CITY PLAN COMMISSION REPORT

Project Velvet (Golden Plains Tech Park)

- #7.1 CD-CPC-2021-00104 Area Plan Amendment
- #7.2 CD-CPC-2021-00105 Area Plan Amendment
- #7.3 CD-CPC-2021-00106 Major Street Amendment
- #7.4 CD-CPC-2021-00107 Area Plan Amendment
- #7.5 CD-CPC-2021-00108 Area Plan Amendment

Plan Conditions, Corrections, & Recommendations Report

PRELIMINARY PLAT
 project: [signature] contract: [signature]
 drawing: C2 sheet 3 of 17 rev. 1
 file: [signature] sheets: [signature]

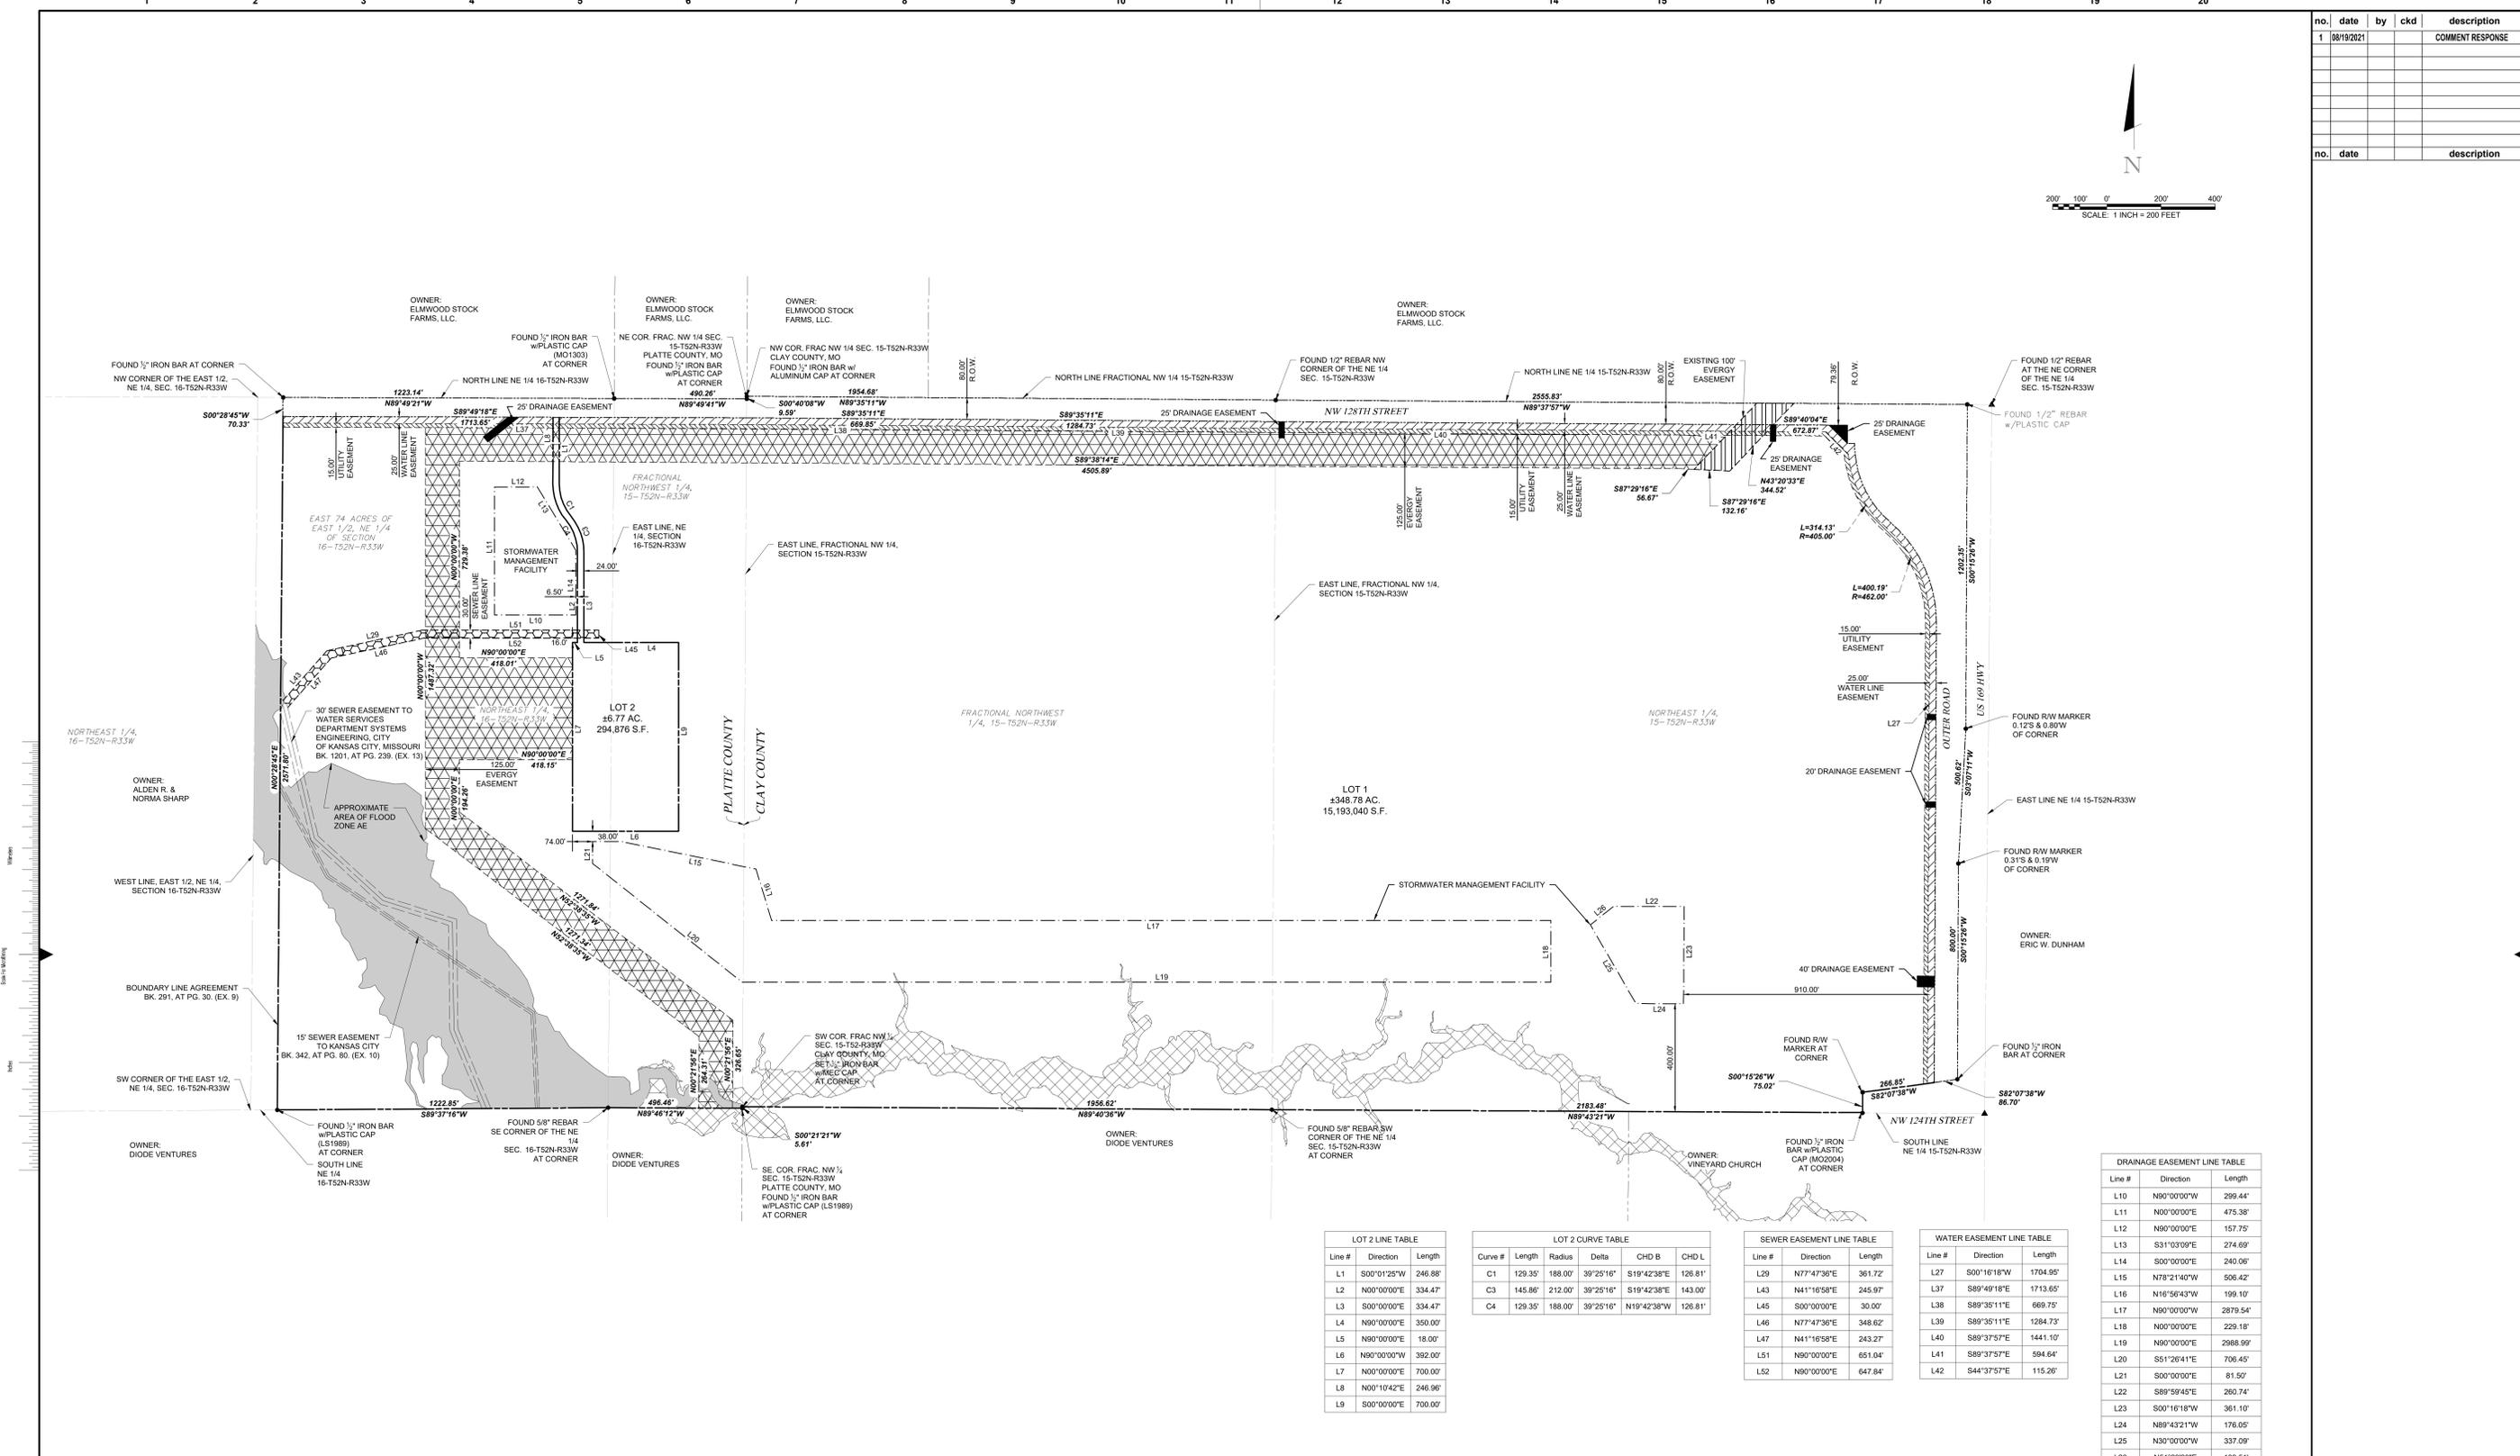
33. Add a note to the Preliminary Plat stating the developer will construct the 10' wide trail along Outer Road and the trail is to be maintained by the City. (7/28/2021)

31. Add a note to the Preliminary Plat stating the developer will construct the 10' wide trail along Outer Road and the trail is to be maintained by the City. (7/28/2021)
